AGENDA
FARRAGUT MUNICIPAL PLANNING COMMISSION

June 16, 2016
7:00 p.m. Farragut Town Hall

SUBJECT: Discussion and public hearing on a site plan for Premier Eyecare, located at 11111 Kingston Pike, Parcels 22-24, Tax Map 143A, Group A, Zoned C-1 and FPD, 3 Lots, 2.22 Acres (Urban Engineering, Inc., Applicant)

SUBJECT: STAFF COMMENTS ON THE SITE PLAN FOR THE PREMIER EYECARE, 11111 KINGSTON PIKE

Sheet Title:
SHEET ELEV02 (SHEET 14 of 15)

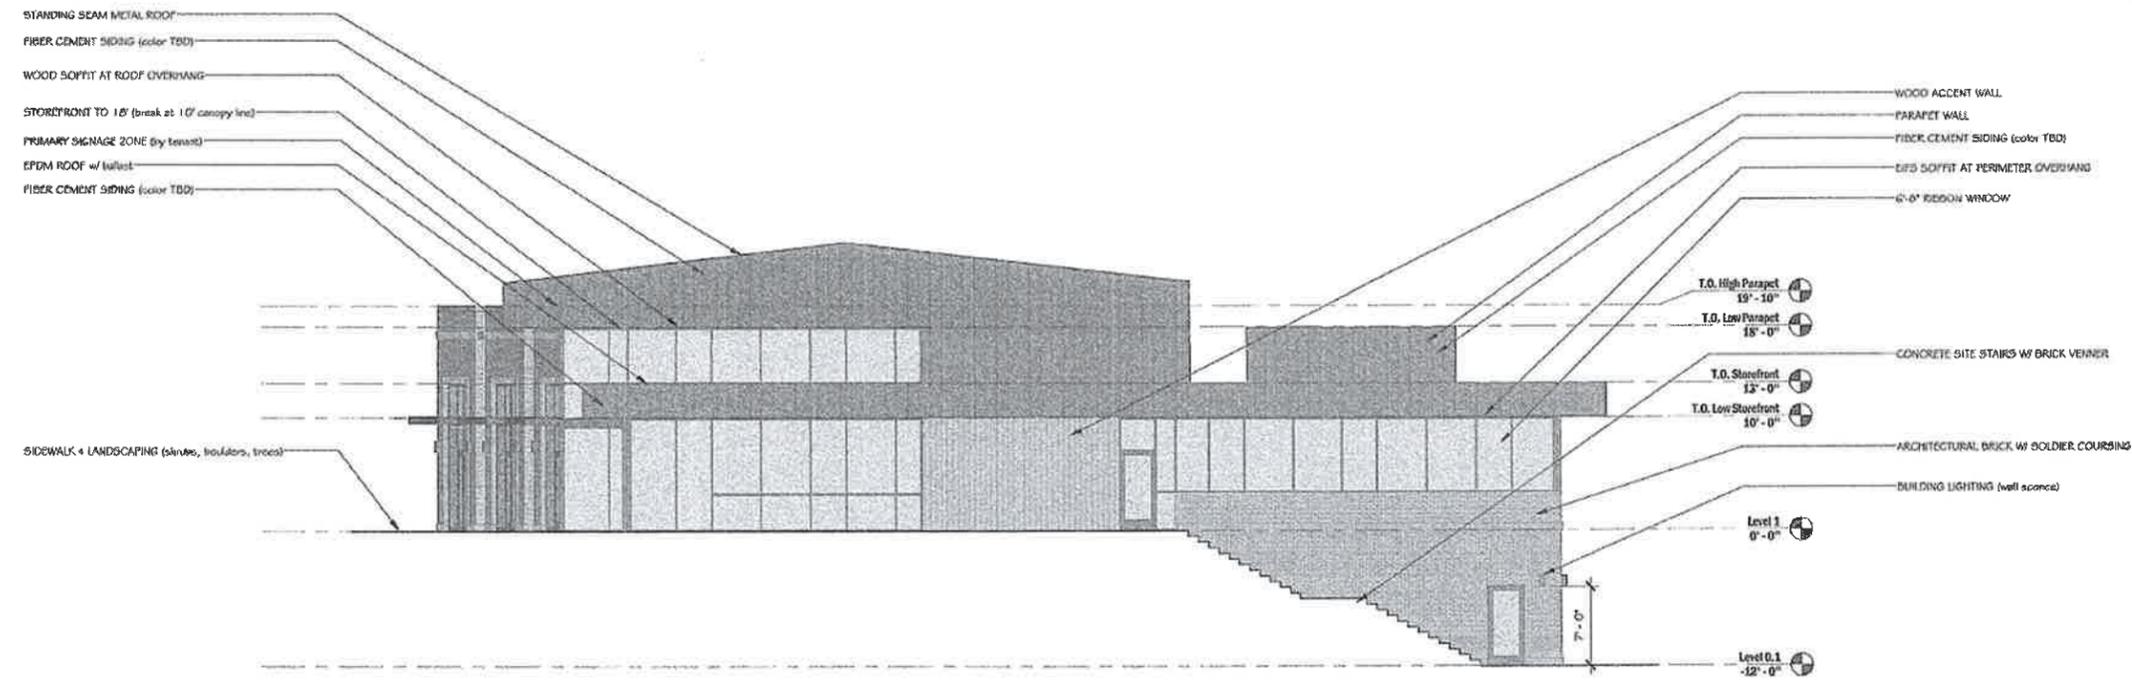
- 24) Please show what the wall light fixtures will look like on the building and that they will not exceed 15 feet in mounted height;
- 25) Please remove all non-regulatory signage from this submittal. Signs are reviewed as part of a sign permit process and are not part of the site plan review;

19. Architectural signatures and seals have been added to Sheets ELEV01 and ELEV02 per comment.
20. The electric sheets have been sealed and signed per comment.

24. A dimension to the bottom of the exterior light fixture has been added to Sheets ELEV01 and ELEV02. A specification sheet has also been attached to this submittal.

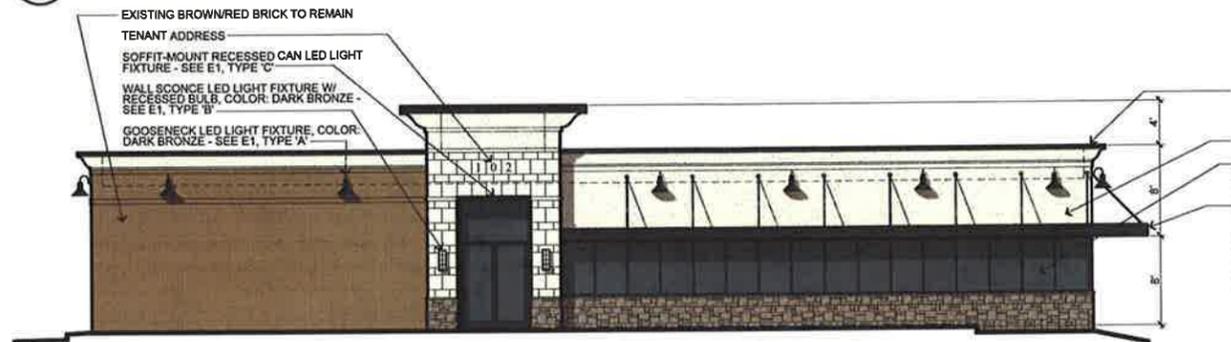
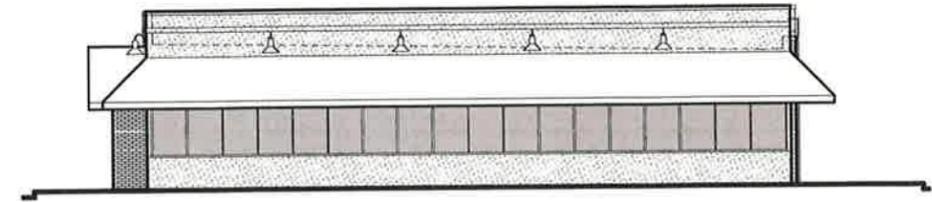
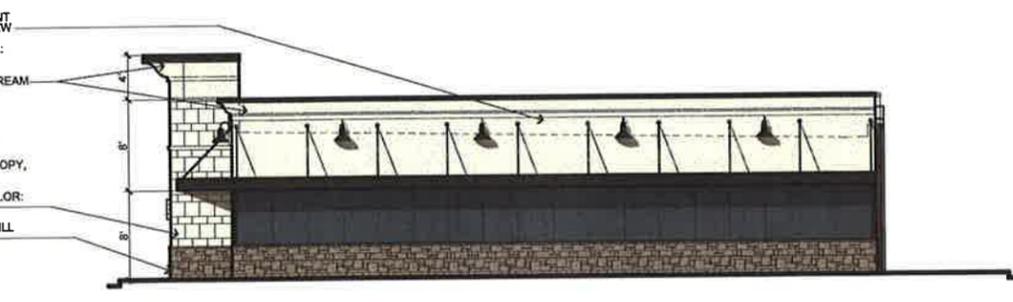
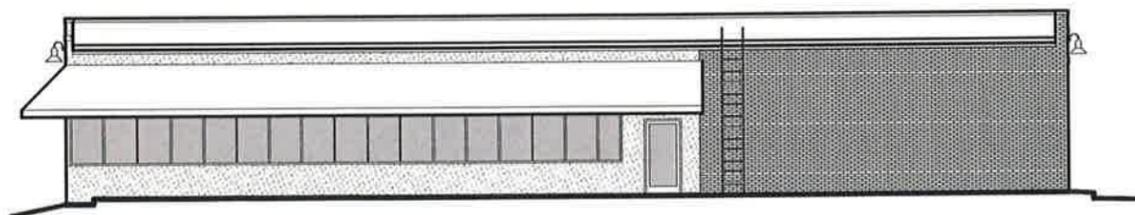
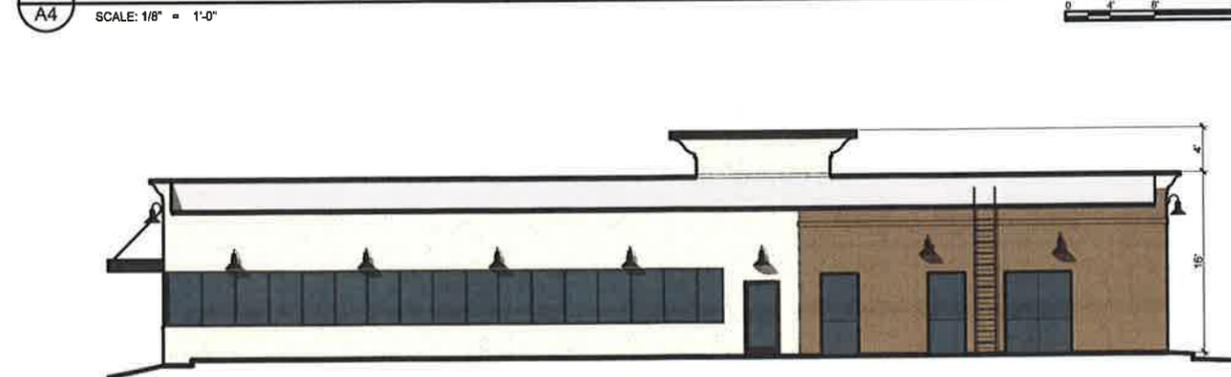
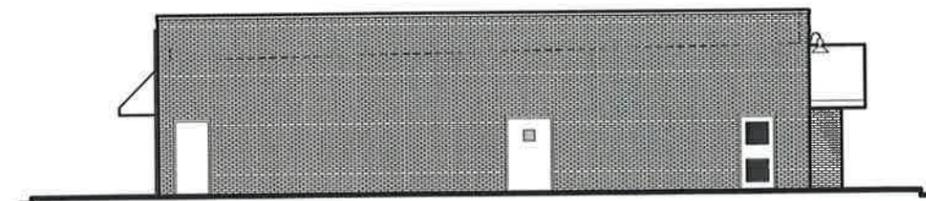
- 3) As it appears, the net façade area will have more masonry than the existing condition. Please confirm in a note on the plans;
- 4) Please confirm if any existing lights are being modified (e.g. the parking lot pole lights);

- 5) Please demonstrate on the lighting sheet that all wall lights shall direct light only at the ground. Light distributed out the front or sides of the fixture is not permitted. No portion of the bulb or material surrounding the bulb which allows light through shall protrude from the light box/housing. Decorative wall lights must be frosted or refractive with regard to light distribution. Clear non-horizontal lenses are not permitted. The light source shall not protrude from the fixture enclosure and the total delivered lumens (which the plans must address) from the fixture shall not exceed 950 lumens. Please verify with an electrical engineer;
